| Office Action Summary | Application No. 10/581,513 | Applicant(s) KAY ET AL. | |

DETAILED ACTION

Claims 1-11 rejected under 35 U.S.C. 102(b) as being anticipated by Lund (U.S. Patent 5,273,190). Lund discloses a syringe for dispensing foam (see abstract and paragraph at column 1 lines 15-25) comprising a syringe plunger with front face(32) with a waste chamber (interior space which components 16 and 18 are contained in), a syringe barrel (12) with a nozzle (22) and bore (internal cavity and internal surface of

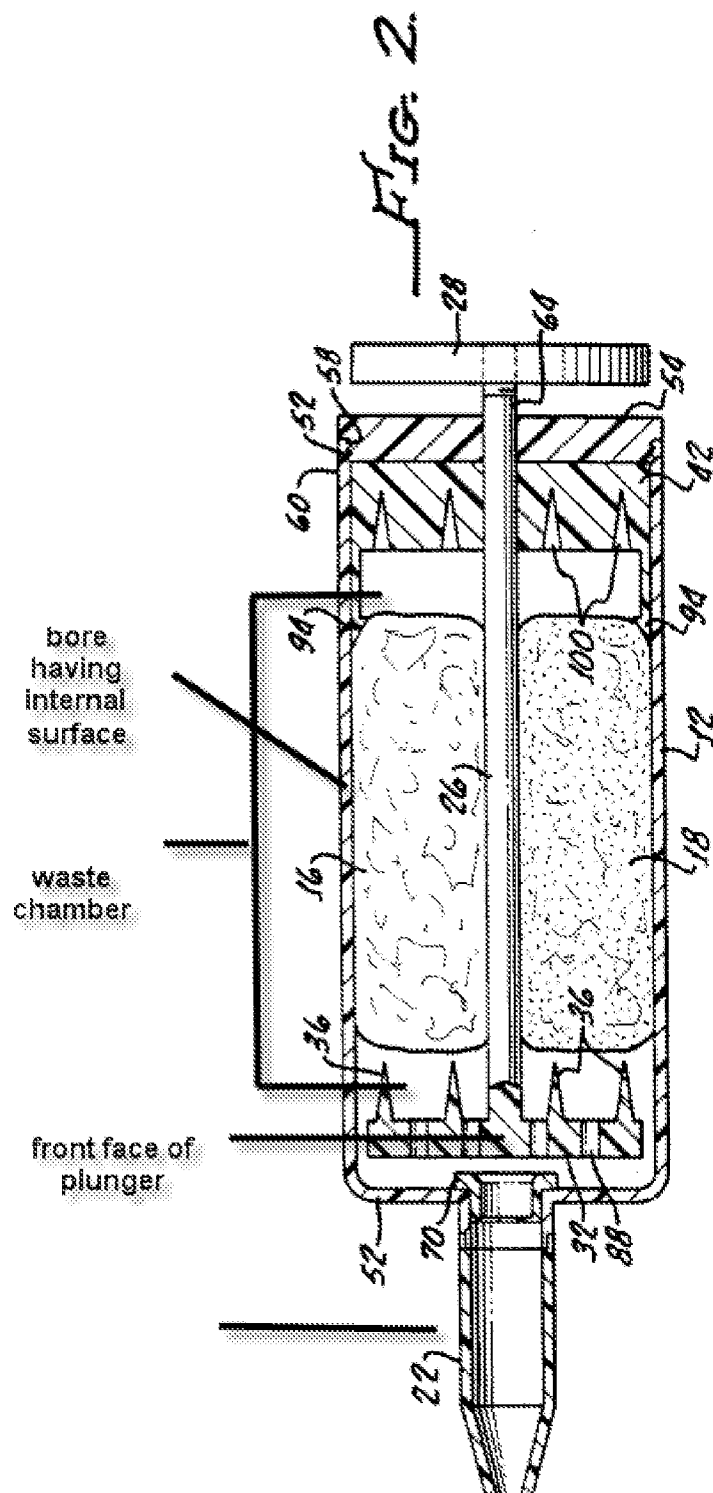
12), a seal formation (42) for sealing between the front face of plunger and said inner surface of the bore. See figure 2 and figure 4 marked up below.

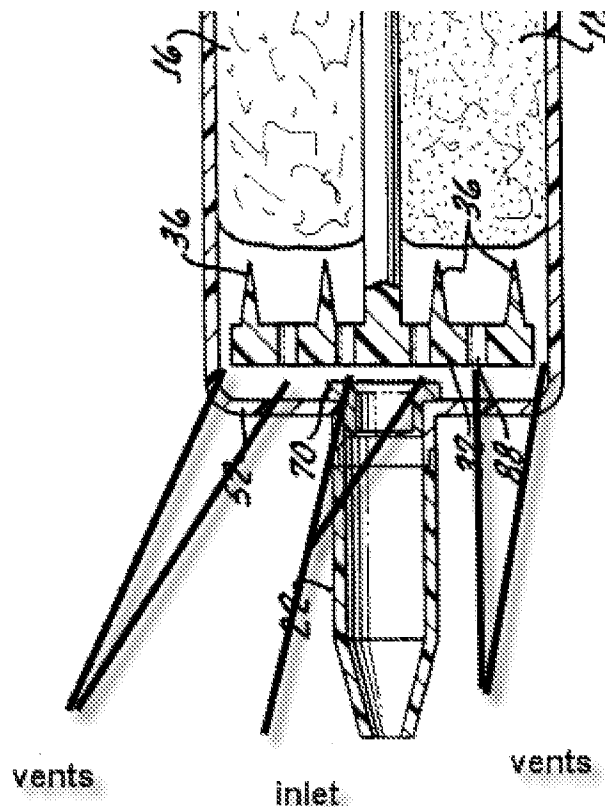
12). Concerning claim 6 it is examiners position that element 42 is a flexible wall within the device but substantially inextensible (incapable of being extended or stretched), Element 32 is of a finite size and does not expand or stretch. Concerning claim 7 note inlets (inner most 88). Concerning claim 8 see marked up lower part of figure 2 below.
